WATER DISTRIBUTION SYSTEM to serve EAST GATE SHOPPING CENTER

8011 E KELLOGG DR.
CITY OF WICHITA, KANSAS

Gary Janzen, P.E. City Engineer
Project Number
2022-004988 PPW (54030980)

EASTGATE SHOPPING CENTER
SIERRA TRADING POST

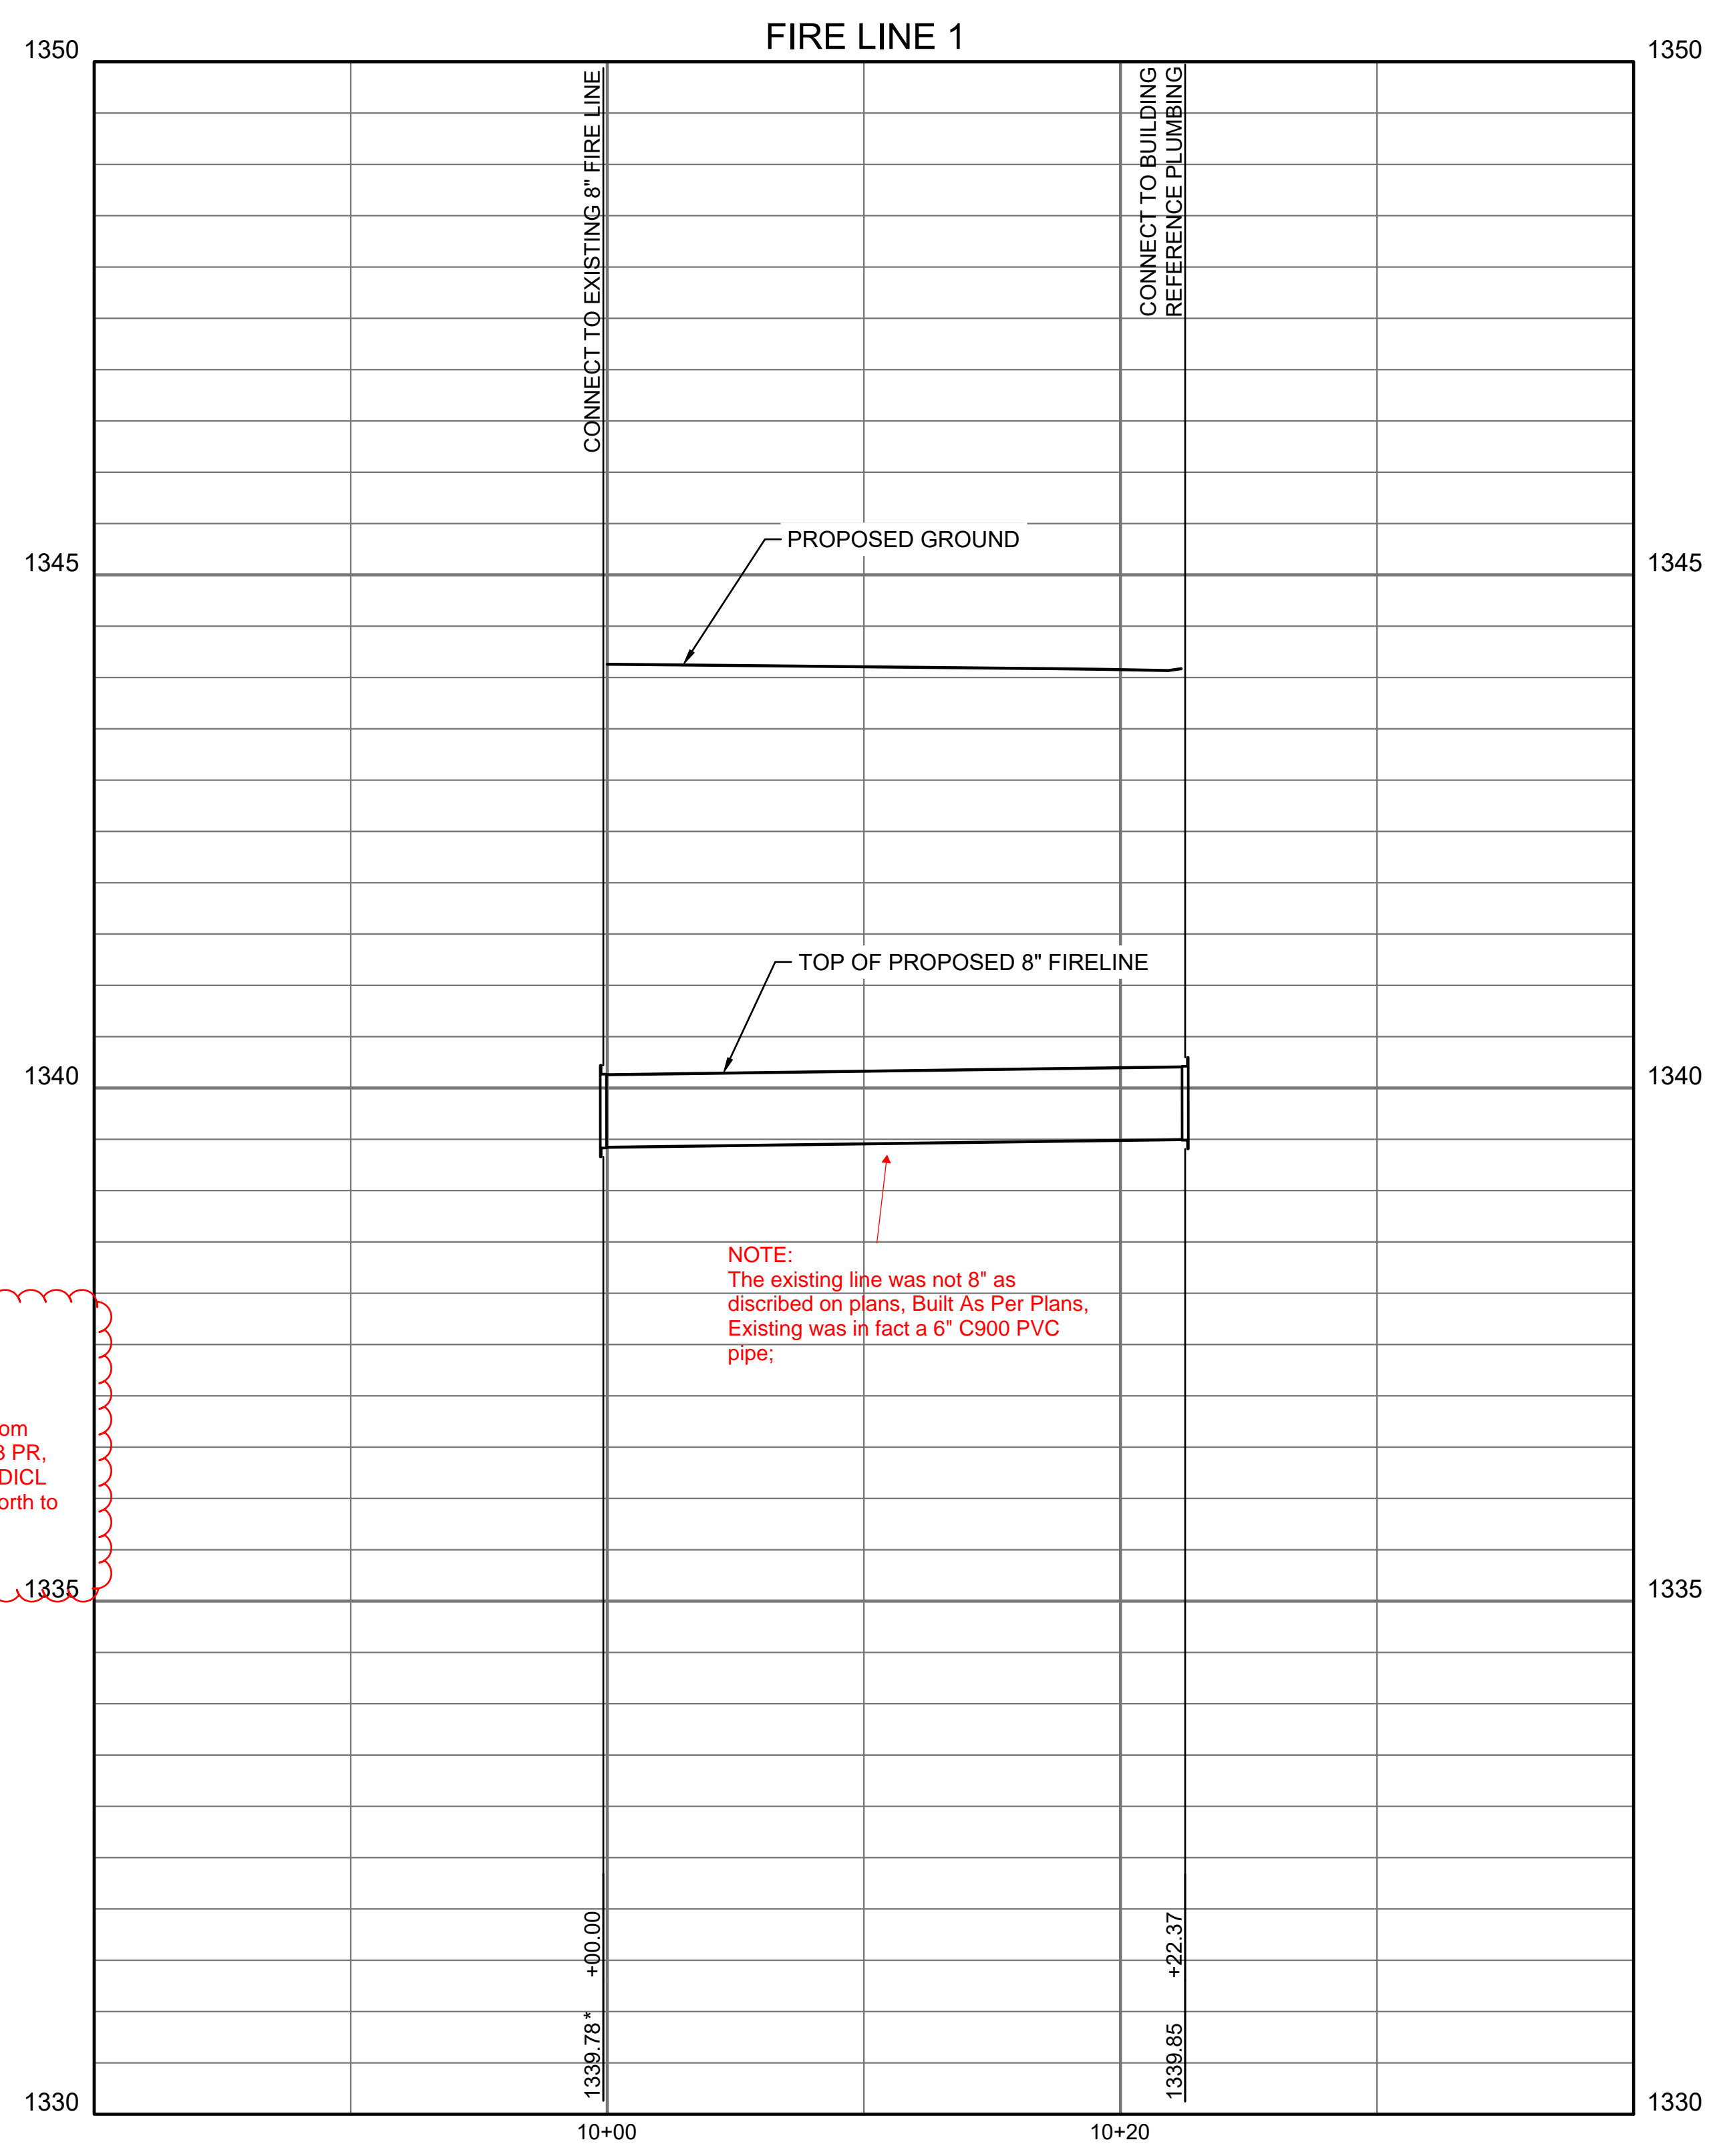
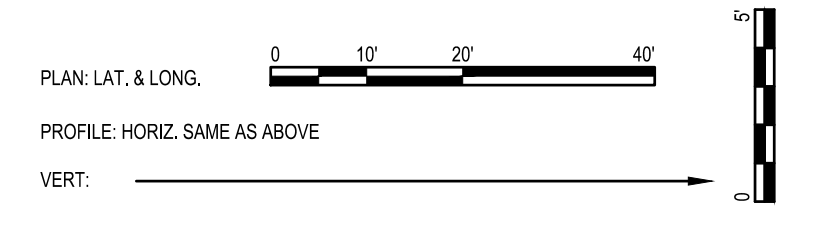
NOTE:
 The existing line was not 8" as described on plans, Built As Per Plans, Existing was in fact a 6" C900 PVC pipe; There is possibly a 8"x6" reducer farther out away from BLDG.

NOTE:
 Not As Per Plans; Location: From Datum: Sanitary MH 6046-243 PR, 24.5 ft. West/19 ft. North to 6" D1CL 90° bend, 11.5 ft West/19 ft. North to Riser. sta. 10+23.30

NOTE:
 The existing line was not 8" as described on plans, Built As Per Plans, Existing was in fact a 6" C900 PVC pipe;
